Re: Approval of Change Order #14 with Pence/Kelly Contractor

CHANGE ORDER

PROJECT: Courthouse Square
(name, address) 555 Court Street NE
Salem, Oregon 97301

CHANGE ORDER NUMBER: 14

Operator Control
Detail # 5

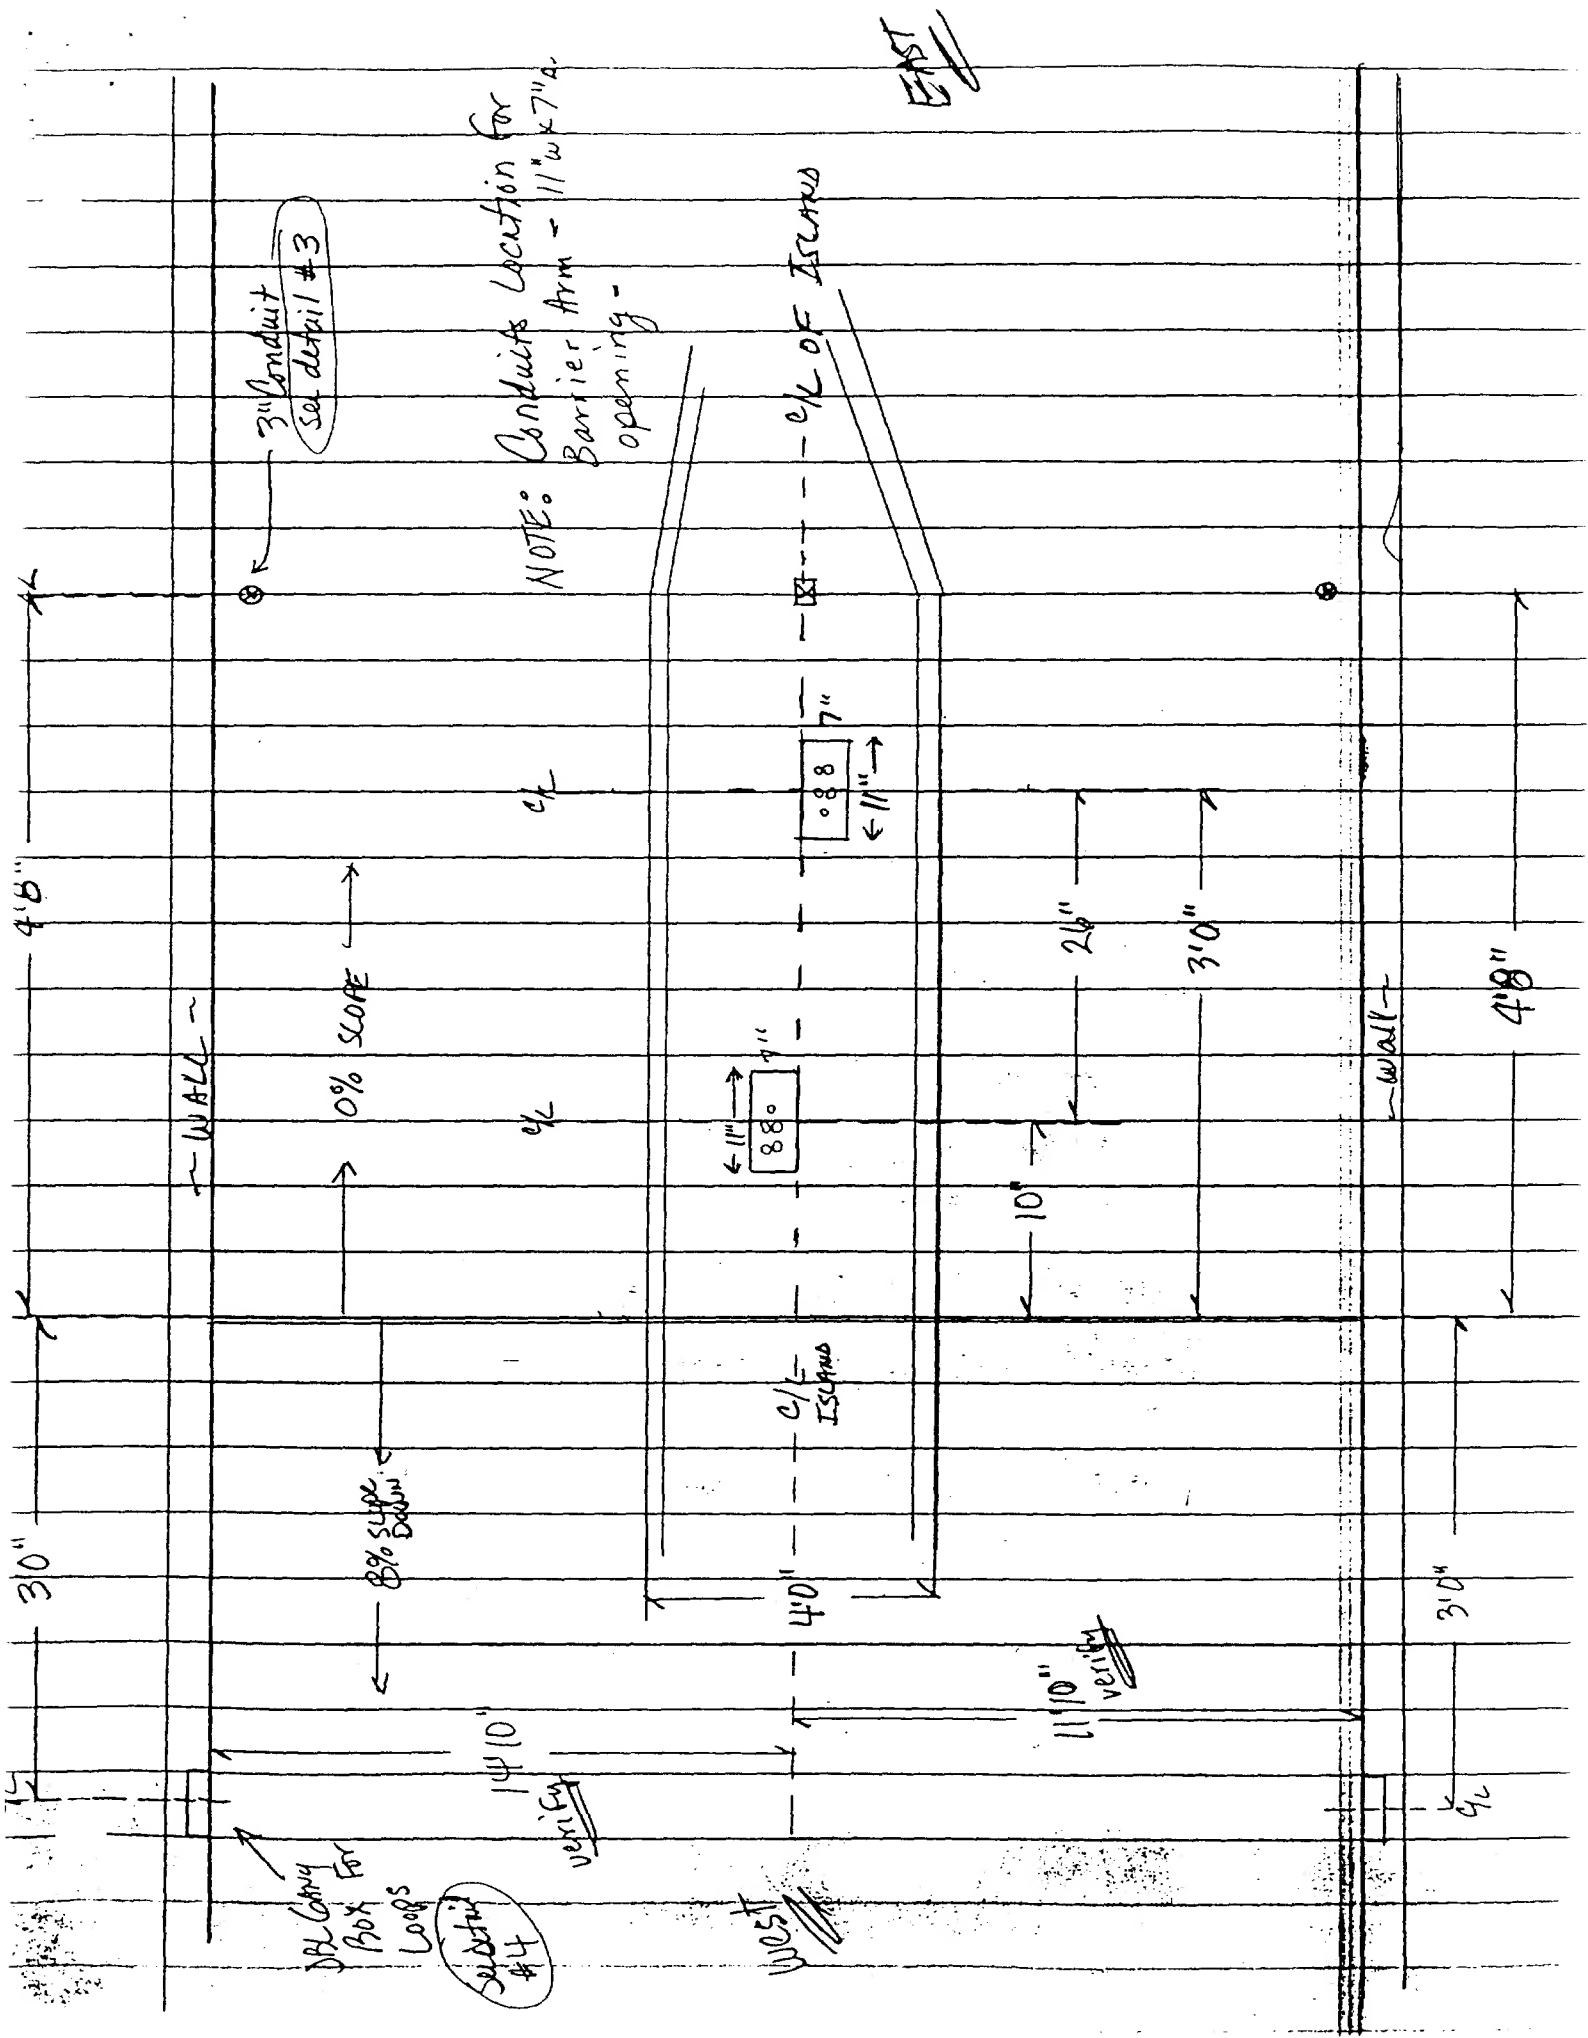
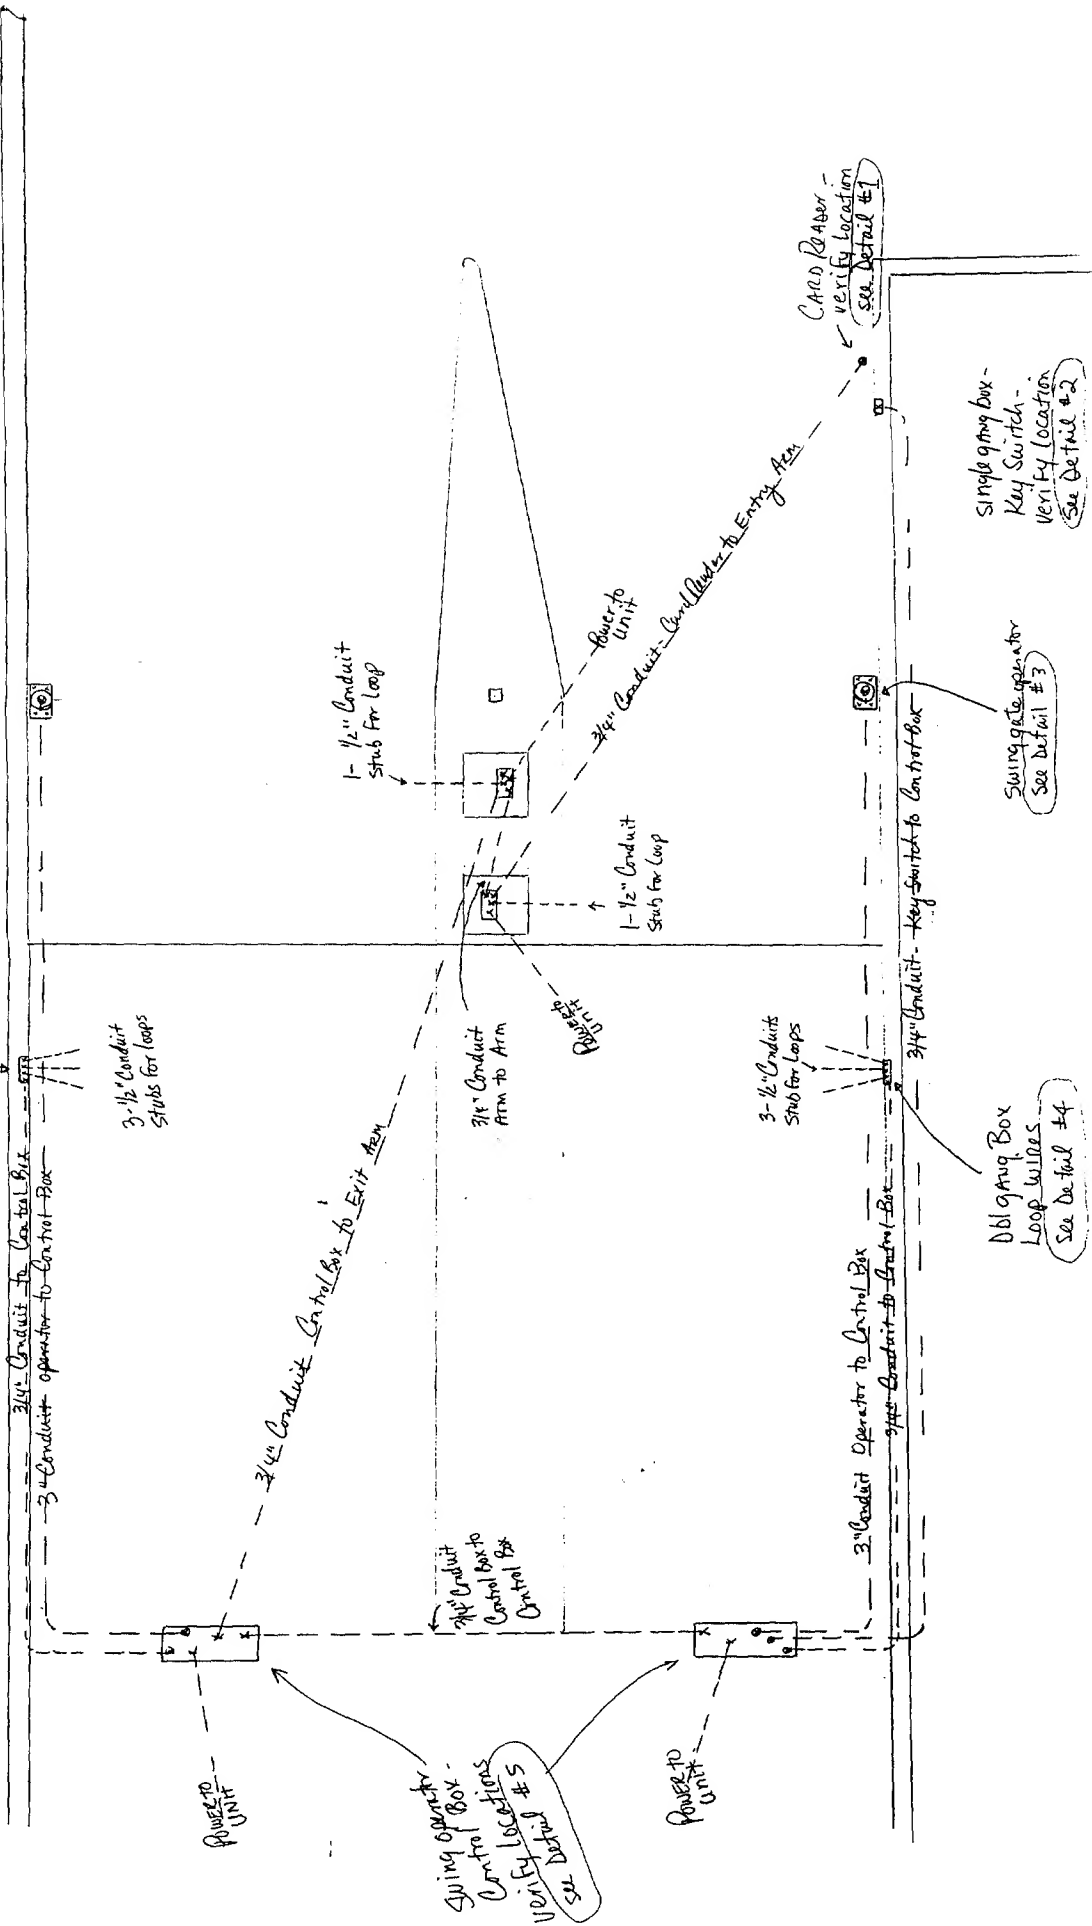
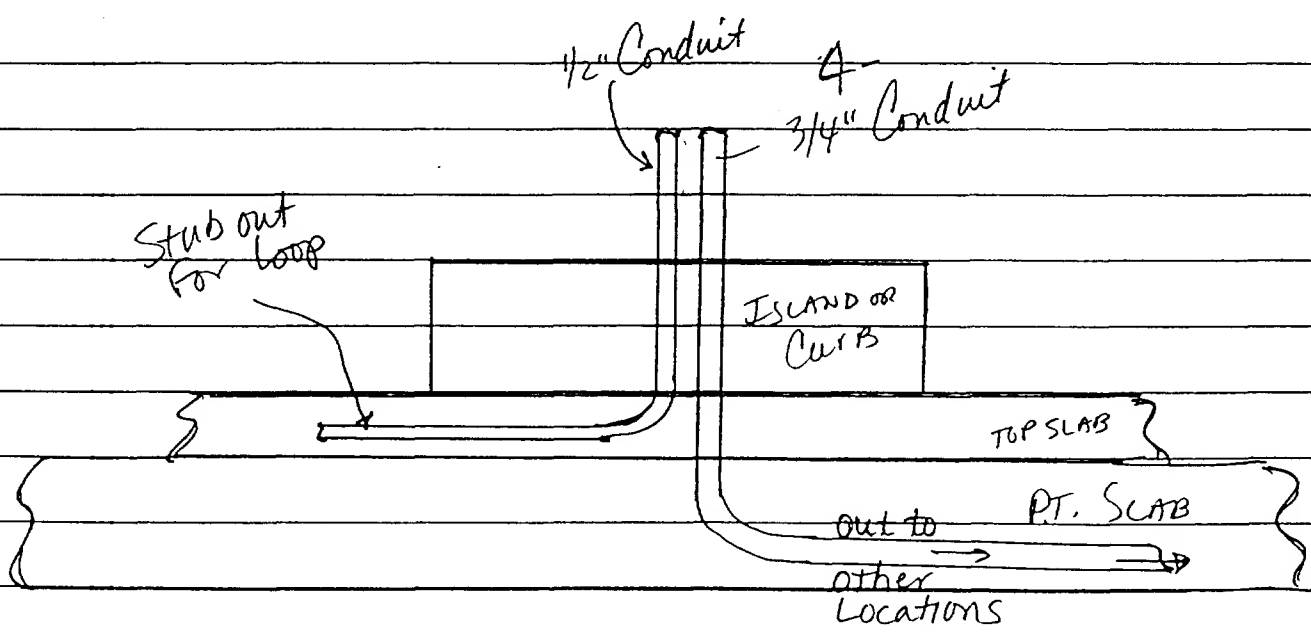
Provide additional conduit for Swing Gate Operator per approved submittal 02710-001

After meeting with the installer of the Swing Gate Operators, it was determined that their installation required a conduit system in excess of that shown on the project plans. Based on a sketch provided to us, we have priced the additional work required.

NOTE: Loops to be Pre-Form Style AND
INSTALLED PRIOR TO TOP SCAB
POUR by Outdoor Fence. Actual
Locations to be determined in field.

NOTE: Conduits Location for
Barrier Arm - 11" w x 7" d.
opening -

Revised
9/8/99
RFI # 348

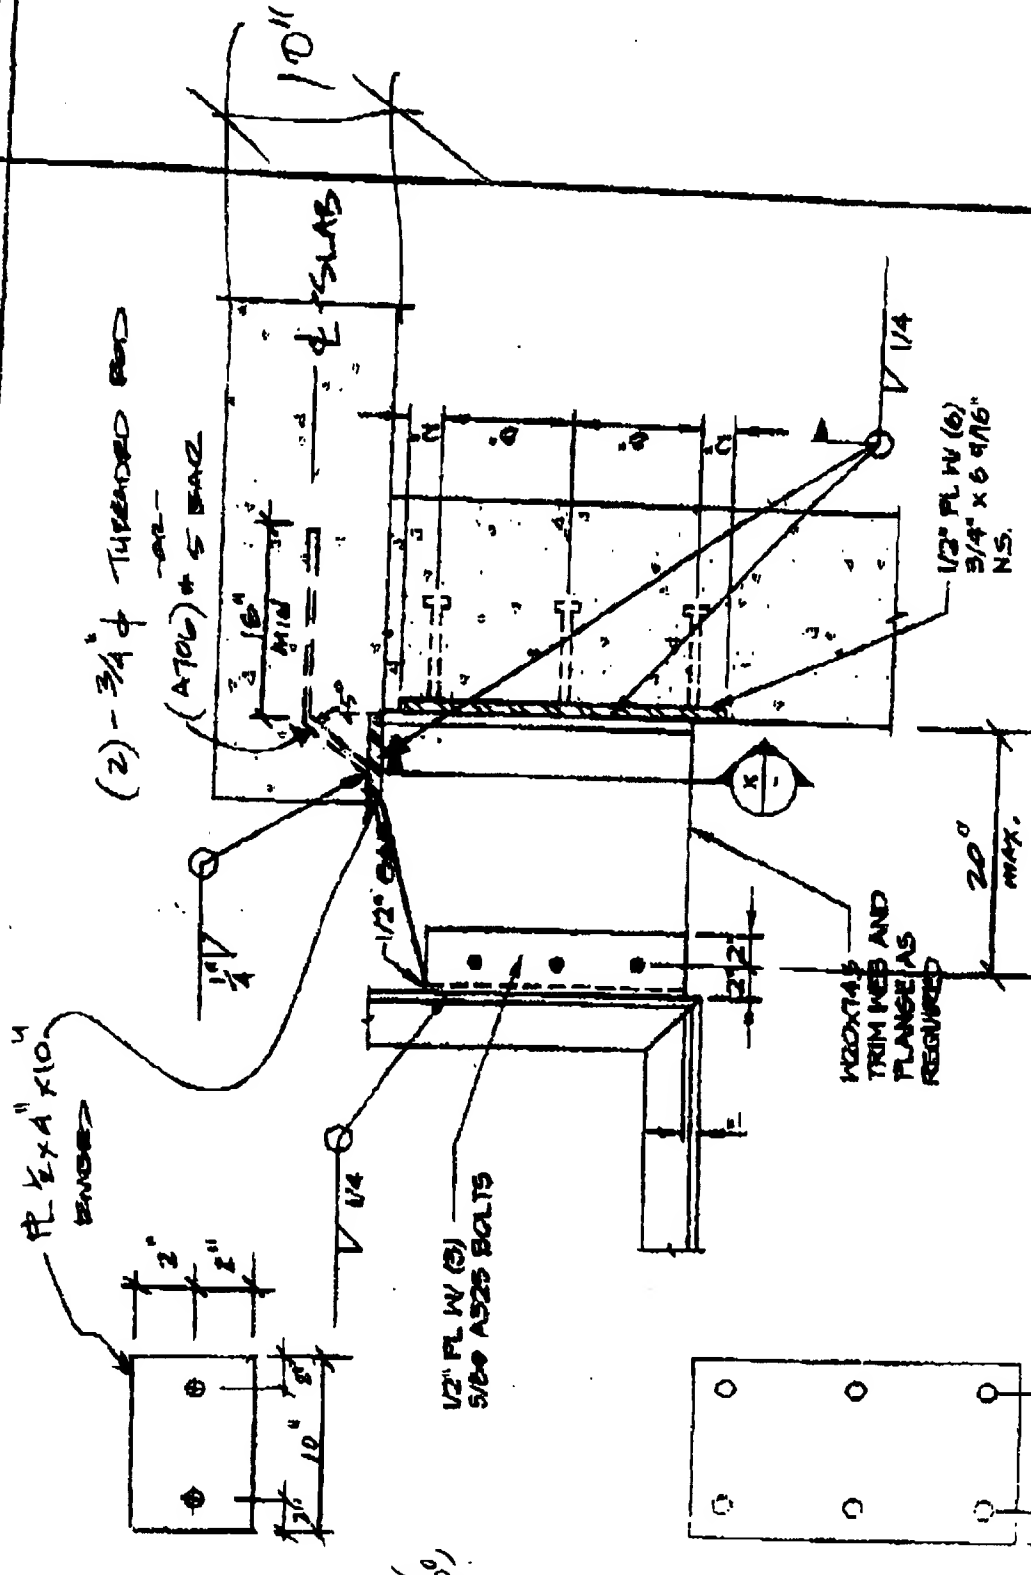
Please review RFI 343; Bridge Connect to East Arcade, for possible change in cost to your contract. You must notify Pence/Kelly within 2 days and submit cost within 10 days.

ADD EMBED AT BRIDGE PER STEVE / TIM
